COMPLETE REVISION HISTORY TO THE 2015 I-CODES[®]

**Complete Revision History to the 2015 I-Codes: Successful Changes and
Public Comments: 2015 IFC**

Why did IFC/2015 section 905.4 change from the 2012 edition? This Complete Revision History to the 2015 I-Codes: Successful Changes and Public Comments: 2015 IFC has been compiled to provide the answers to such questions.

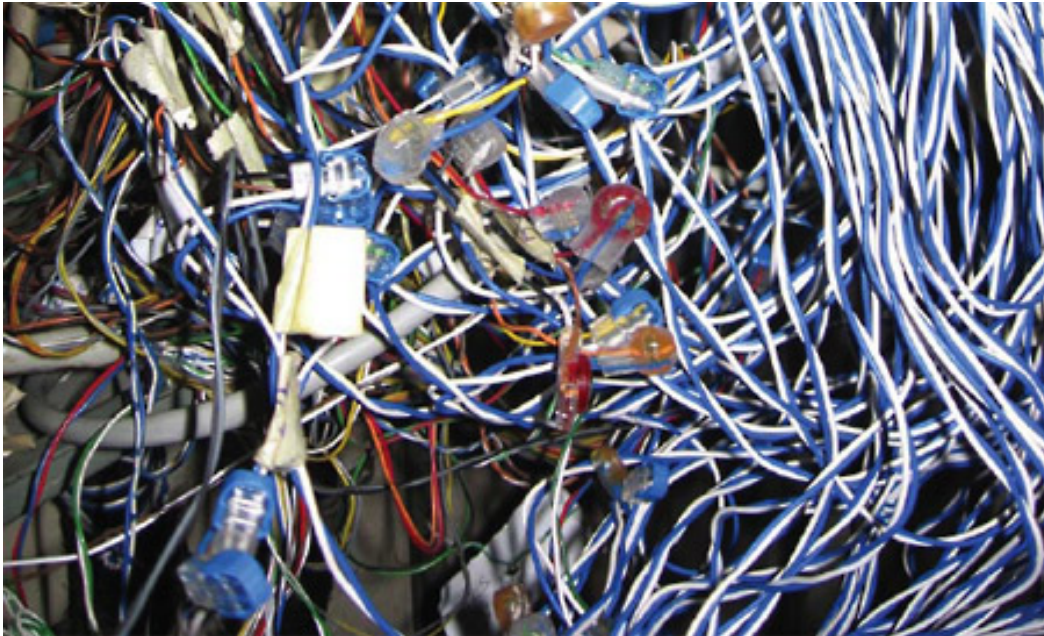
Reason: This new section is intended to introduce a concept that has been in the National Electrical Code (as well as in NFPA 90A) for a long time: plenums are intended for a specific use (see definition below), namely to be a part of the air distribution system so as to allow air movement. Plenums are also used (legitimately) for stringing communications and data cables as well as pipes and sprinkler pipes and other similar products. However, in actual fact, it is a common practice not to make the effort to remove products when they become obsolete. Examples include when an updated data system is being installed in the facility (and that typically occurs every 18-24 months). Normally, as the building is being rewired the old wires are cut off the grid but they are left in place and a new wiring system is added on top of them.

The tiles that often support plenums are not intended to support any significant weight and they can, therefore easily be overwhelmed by the added weight of storage or abandoned materials (such as abandoned cables). Recently, Bob Davidson and Sean DeCrane (Plenum Space Fuel Load, NFPA Annual Meeting 2009, M33) did an analysis that showed how the safety of firefighters is compromised by the weight of these abandoned cables. They point out that: "Plenum space fuel loads and wiring issues are a serious concern for fire fighters during interior firefighting operations." Their key recommendation was: "Take out the abandoned wiring!!"

The proposal recommends that only the "accessible portions" of abandoned cables be removed, because there is no intent to cause potential damage to the building or facility by attempting to remove cables or circuits that are strung through walls, floors or other building elements.

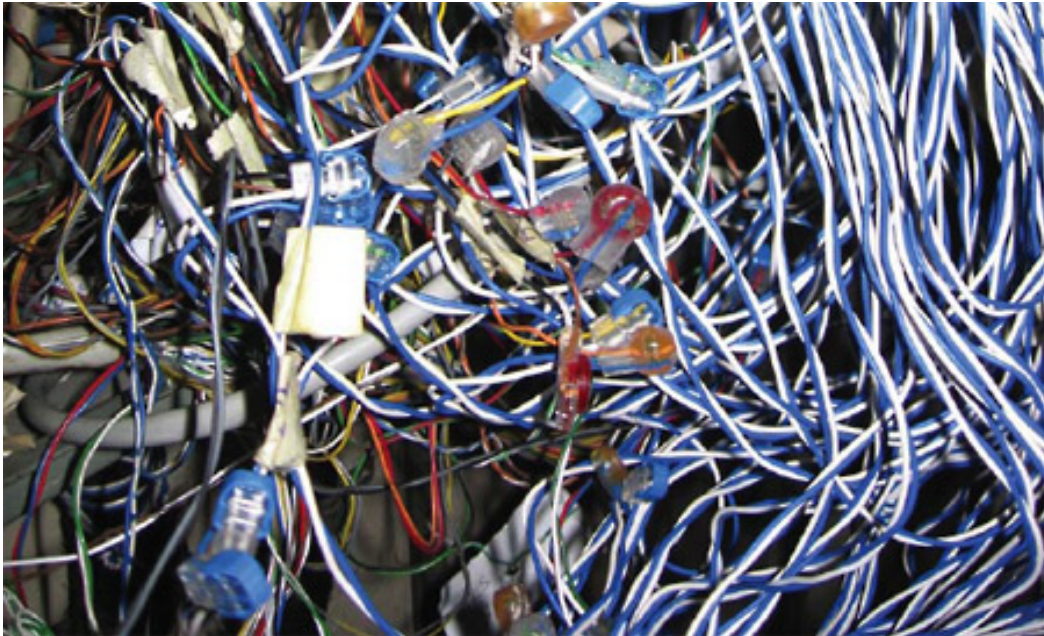
This issue is particularly suitable for Chapter 6 (and section 605) of the IFC since it addresses electrical equipment, wiring and hazards, which are not necessarily electrical hazards but address other safety issues, such as illumination, temporary wiring and unapproved conditions, compliance with all of which is being inspected by the fire code official.

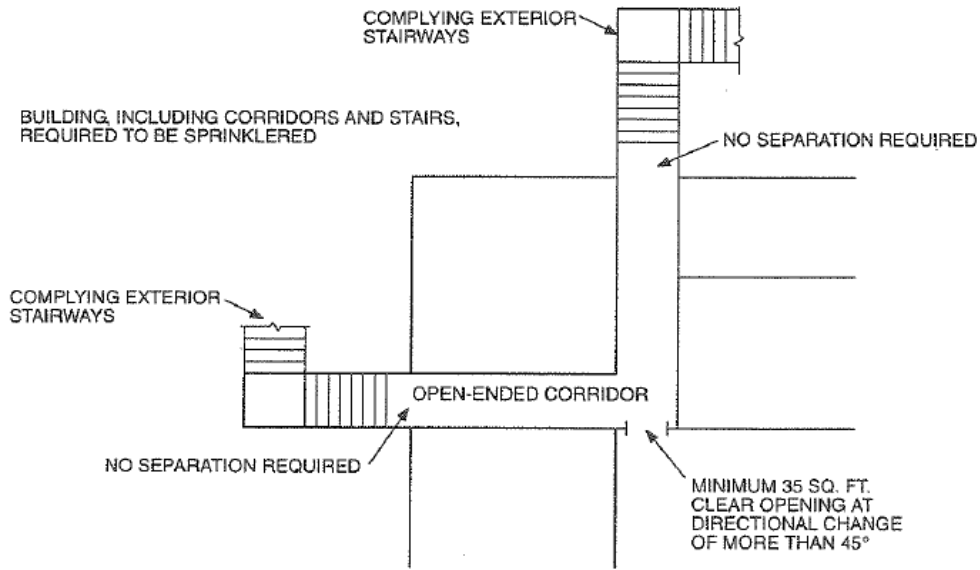
Reason: This is a correlation with code change E153-12 which was approved last cycle. New Section 903.3.1.2.2 is to clarify that when using a 13R system for this provision, extra heads are required in the breezeway.

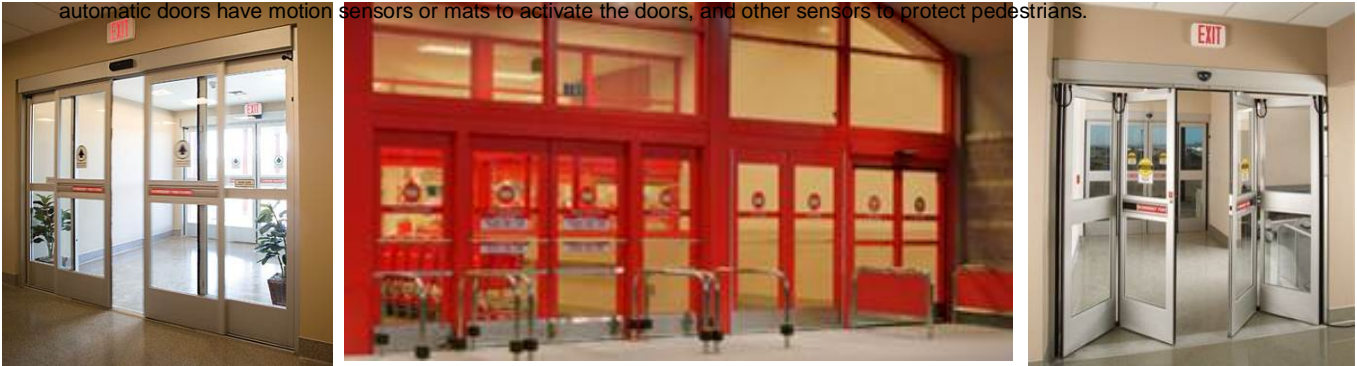
Commenter's Reason: This intent of this proposal and this public comment is to improve the code by defining / describing the types of doors this section of the code applies to while not revising the technical requirements of the code. We've attempted to address the committee's comments with revisions to the definitions and slight changes to 1008.1.4.2 (adding a comma, and deleting a comma).

1008.1.4.2 (IFC [B] 1008.1.4.2) Power-operated doors. Where *means of egress* doors are operated or assisted by power, the design shall be such that in the event of power failure, the door is capable of being opened manually to permit *means of egress* travel or closed where necessary to safeguard *means of egress*. The forces required to open these doors manually shall not exceed those specified in Section 1008.1.3, except that the force to set the door in motion shall not exceed 50 pounds (220 N). The door shall be capable of swinging open from any position to the full width of the opening in which such door is installed when a force is applied to the door on the side from which egress is made. Power-operated swinging doors, power-operated sliding doors, and power-operated folding doors shall comply with BHMA A156.10. Power-assisted swinging doors and low energy power-operated swinging doors shall comply with BHMA A156.19.

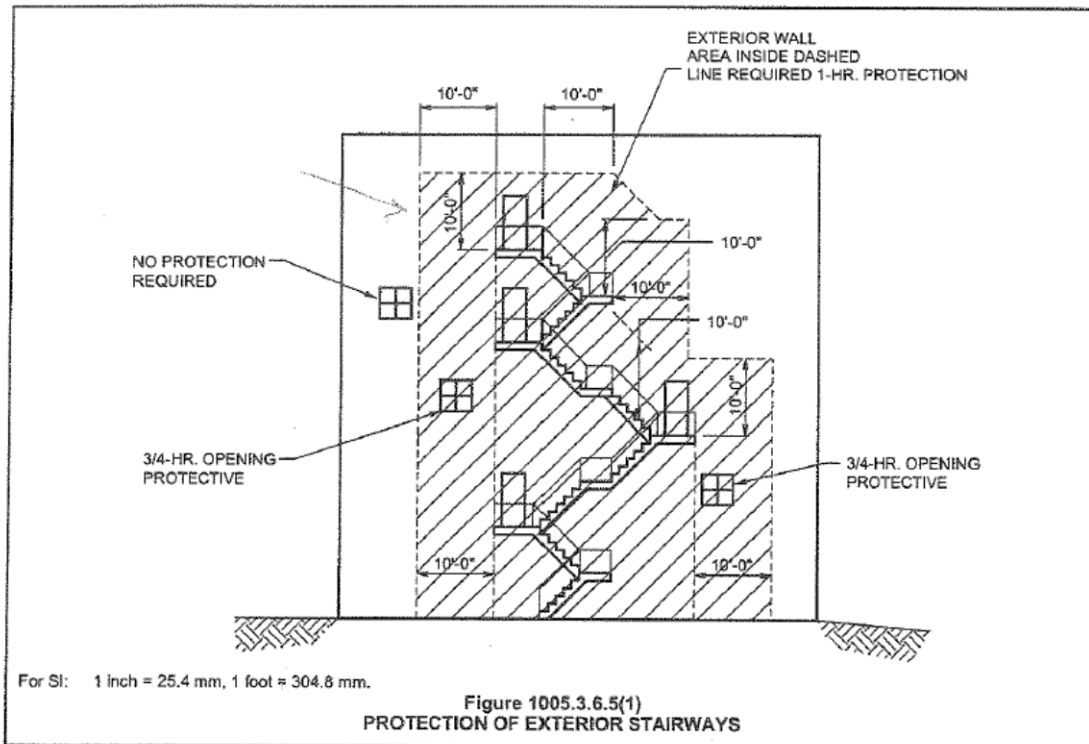
Many designers and jurisdictions assume that breezeway stairs are allowed by right. However, in order to not have to build the wall and fire door separating the exterior stair from the interior corridor, exception 4 must be complied with, which includes sprinklers in this breezeway.

The following is a representation of the intent of Exception 4, allowing the removal of the separation wall and door:
